Florida Department of Environmental Protection (FDEP)  
Technical Advisory Committee (T.A.C.) on...

# STATE-WIDE STORMWATER TREATMENT RULE DEVELOPMENT

AN ISSUES PRESENTATION BY  
**DEVO SEEREERAM, PH.D., P.E**  
DEVO ENGINEERING, ORLANDO, FL  
([WWW.DEVOENG.COM](http://WWW.DEVOENG.COM))  
APRIL 16, 2008

**SOME PRACTICAL IMPLICATIONS OF THE IMPLEMENTATION  
OF PROPOSED DRAFT STATE-WIDE STORMWATER TREATMENT RULE**  
These Are Only Advisory Comments to the T.A.C. & Rule-Making Staff  
“food for thought”

### Required Pond Size and Developable Area for Conversion from Various Initial Land Usage to Single Family Development for Orlando

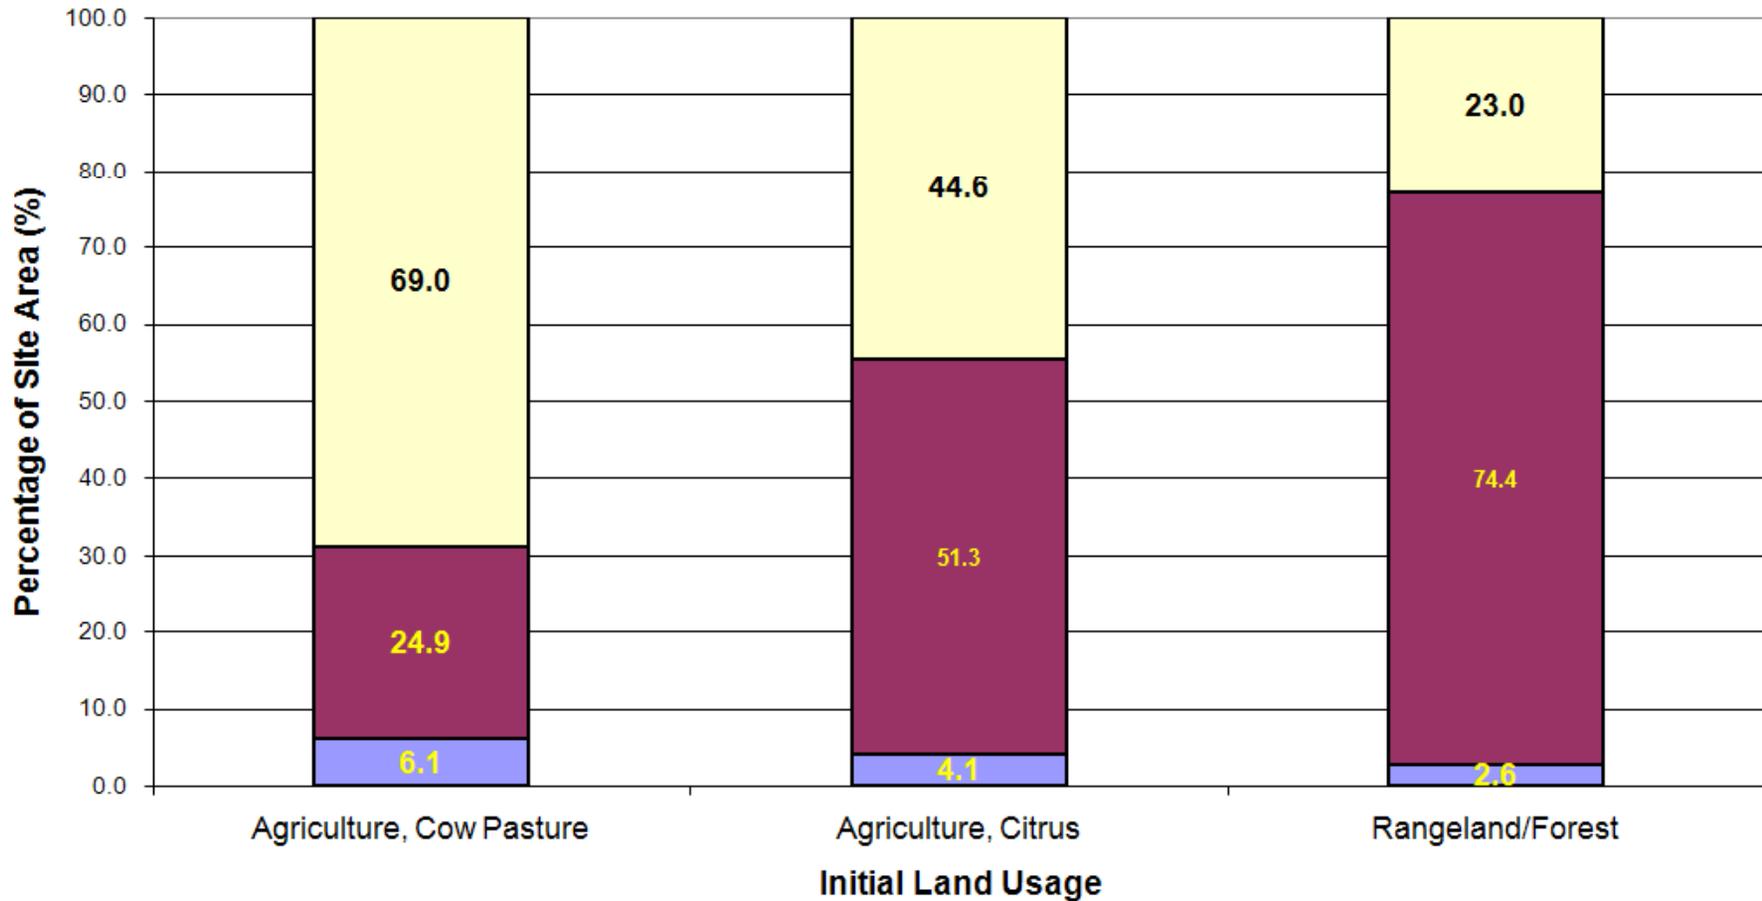
## Hypothetical Wet Pond Only

Predevelopment Conditions: CN = 75, DCIA = 0  
 Postdevelopment Conditions: CN = 75, DCIA = 35%

Required Wet Pond Size and Developable Area for Conversion from Various Initial Land Usage to Single Family Development for Orlando

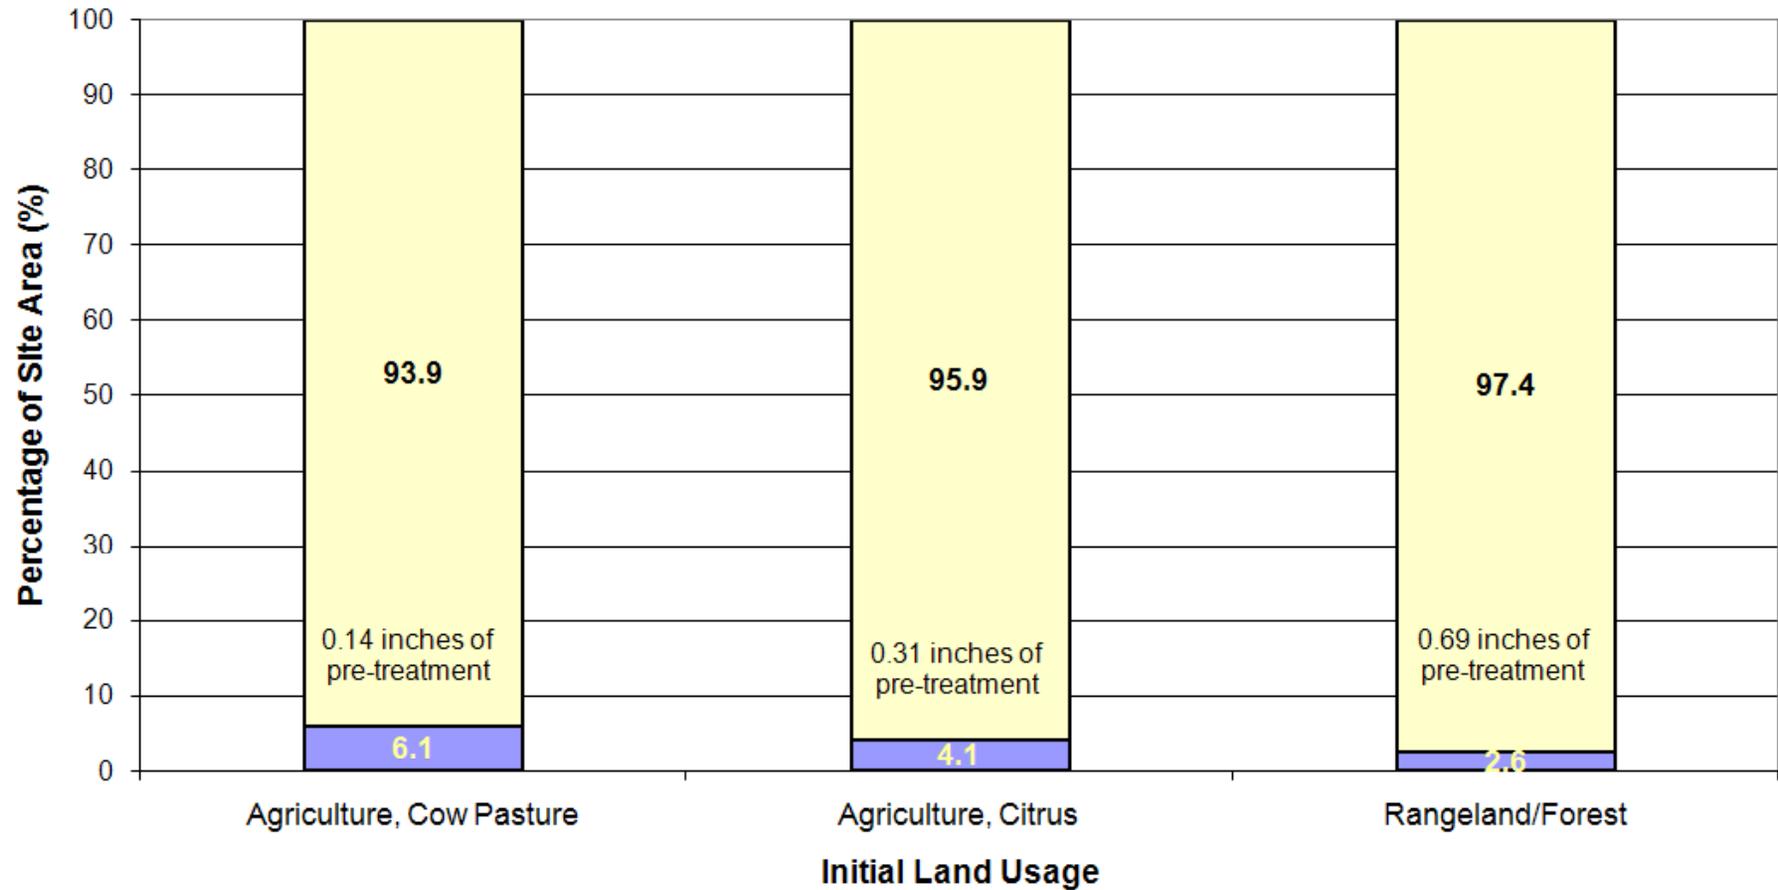
## Dry/Wet Treatment Train

Predevelopment Conditions: CN = 75, DCIA = 0  
Postdevelopment Conditions: CN = 75, DCIA = 35%
